L-MT-09-008
Technical Specification 5.6.3

Monticello Nuclear Generating Plant
Docket 50-263
Renewed Facility Operating License No. DPR-22

Revision 1 to the MNGP Core Operating Limits Report for Cycle 24

**MONTICELLO NUCLEAR GENERATING PLANT
REVISION 1 TO CYCLE 24 CORE OPERATING LIMITS REPORT
NAD-MN-015, Revision 1**

Figure 8
Monticello Cycle 24
Power Dependent K(P) and MCPR(P) Limits for
Pressure Regulator Out of Service (PROOS)

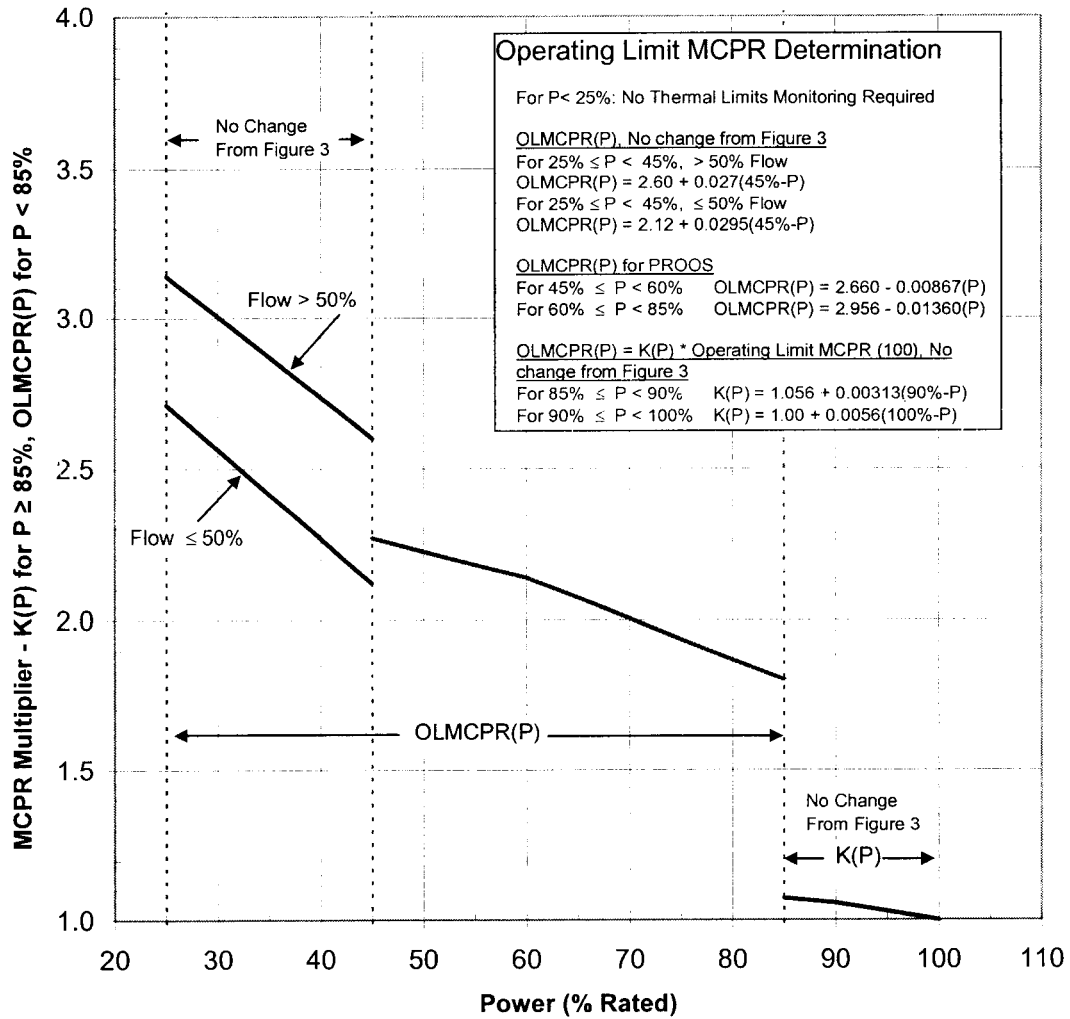
Revision 1 of this report includes thermal limits to permit operation with a Pressure Regulator Out of Service (PROOS), also called operation without a backup pressure regulator. See Section 5.3 for more details.

A Pressure Regulator Fails Down-Scale (PRFDS) event without backup pressure regulator was evaluated for Monticello Cycle 24 (Reference 21). This event resulted in a

more restrictive Power Dependent MCPR limit than required for normal reduced power operation with both pressure regulators operational. Figure 8 provides the required more restrictive power dependent MCPR ARTS limits for powers below 85% and greater than or equal to 45%. For powers greater than or equal to 85% or below 45%, the power dependent MCPR and K(P) ARTS limits provided in Figure 3 are still valid.

Figure 8 combines the unchanged limits from Figure 3 along with the more restrictive limits determined in Reference 21 for PROOS operation. Figure 8 should only be used for operation without a backup pressure regulator. Figure 8 is valid for both Option A and Option B OLMCPR limits.

Then, if core thermal power (P) is ≥ 85% of rated core thermal power, the Option B OLMCPR for all fuel types is the greater of:

$$\text{OLMCPR}_{\text{OptionB}}^{\text{New}} * \{K(P) \text{ from Figure 8}\} \text{ or } \{\text{MCPR}(F) \text{ from Figure 4}\},$$

$$= \text{Maximum of } \{ \text{OLMCPR}_{\text{OptionB}}^{\text{New}} * K(P) \text{ from Figure 8}\} \text{ or } \{\text{MCPR}(F) \text{ from Figure 4}\}.$$

If core thermal power (P) is < 85% of rated core thermal power, the OLMCPR for all fuel types is obtained from Figure 8.

**Figure 9
Pressure Regulator Out Of Service
Interim MFLCPR LIMIT**

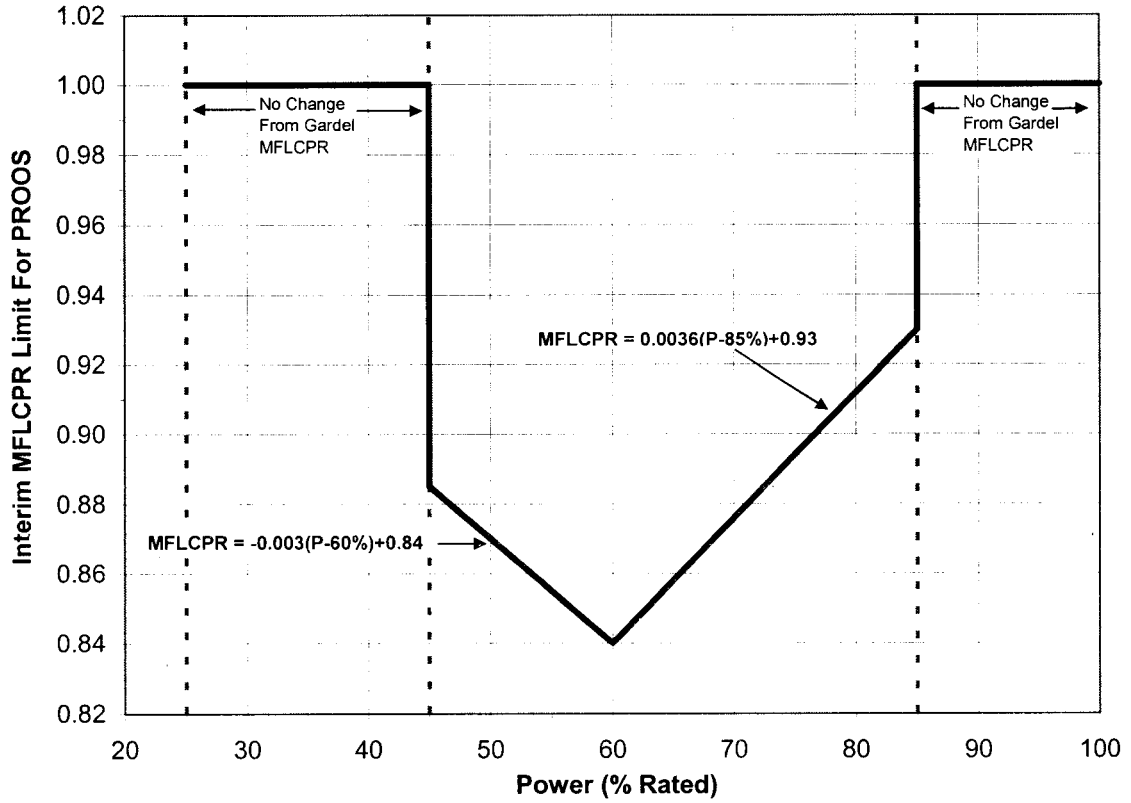
An interim MFLCPR Limit is provided in Figure 9. This limit should only be used if the Gardel thermal limit input has not been modified as described in Sections 5.3.1 or 5.3.2 to account for pressure regulator out of service operation. i.e. Only Figure 8 or Figure 9 should be used to provide the appropriate PROOS limit. These figures should not be utilized in combination.
